Euro Knitwear Limited (Unit-2)

159, Ojarpara, Mollah Market, National University-1704, Gacha, Gazipur City Corp; Gazipur
(23.958650, 90.364458)
9 January 2025

Observation-01: Stress in the foundation exceeds normal design limit. (Production Building)

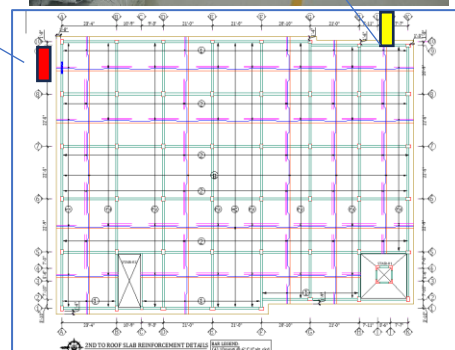
Description: Cursory calculation indicates the internal footings are stressed above the normal design limit for bearing capacity. We considered the observed live load 3 kPa for typical floor. Also, the ultimate bearing capacity of the soil was considered 2.5 ksf, as per soil test report. The building engineer is required to carry out Engineering Assessment (EA) to review the design, load and foundation stresses.

Observation-04: Non-structural elements not anchored or braced. (All structures)

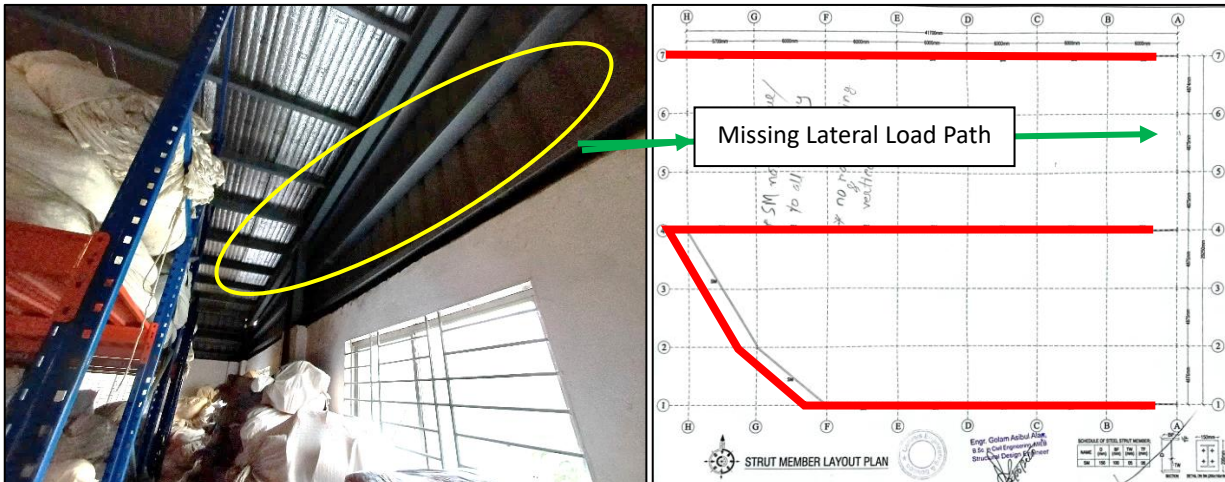
Description: Non-structural elements (PVC tank and Racks) were found on different floors of the building. Which were not properly anchored or braced. Building engineer is required to anchor or brace all non-structural elements to avoid falling hazard during earthquake or any lateral loading.

Observation-06: Incomplete lateral load path. (Grey Fabric Store)

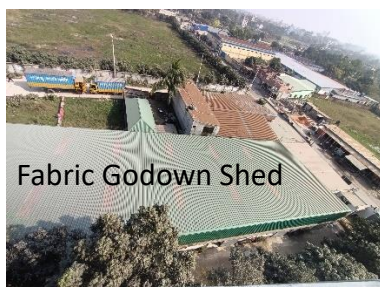
Description: During inspection, the lateral load path was found missing along Grid-A and Grid-H (shown by green arrow). The building engineer is required to check the lateral stability system of the shed.
